- INTERIM REPORT -

SAFETY INJECTION SYSTEM PIPING DEFICIENCY  
November 21, 1979

SOUTH TEXAS PROJECT  
UNITS 1 & 2

FIGURE 1 PIPING LAYOUT

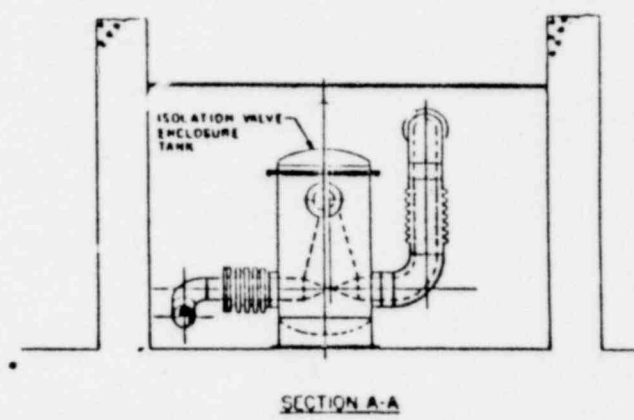
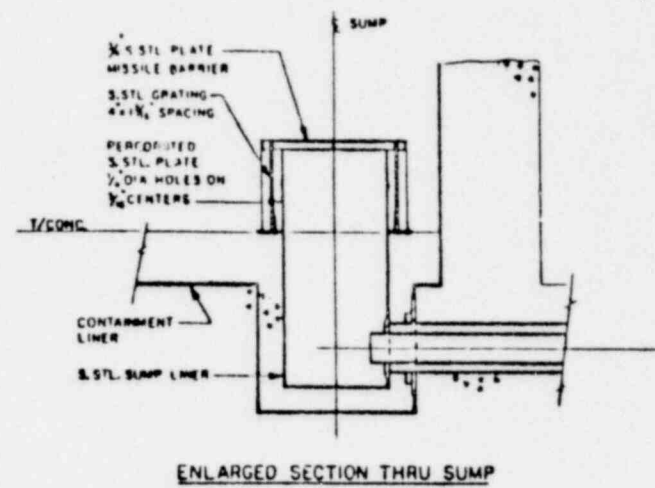
During a routine review, a design deficiency was discovered which, if left uncorrected, could have adversely affected the safety of operations. The joint between the 16 inch Safety Injection System piping and the emergency sump liner was shown on the construction drawing to be a one-quarter inch seal weld, which does not meet the design load criteria. The location of this weld is shown in Figure 1.

FIGURE 2 SYSTEM SCHEMATIC DIAGRAM

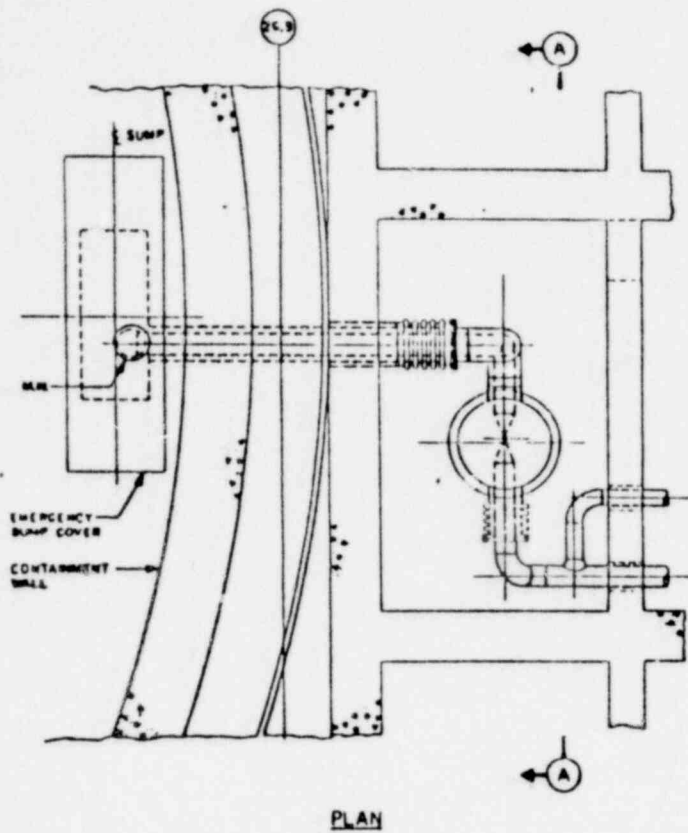
The piping is part of the SIS and CSS and leads from the containment emergency sump through the containment sump isolation valve to the safety injection and containment spray pumps. Following a LOCA, water will automatically be recirculated from the emergency sumps to the reactor by the Safety Injection System. Operation of the containment emergency sump isolation valve is required for recirculation mode operations. The seal weld in question attaches the process pipe to the sump liner. Sketches of this configuration are given in Figures 1 and 2.
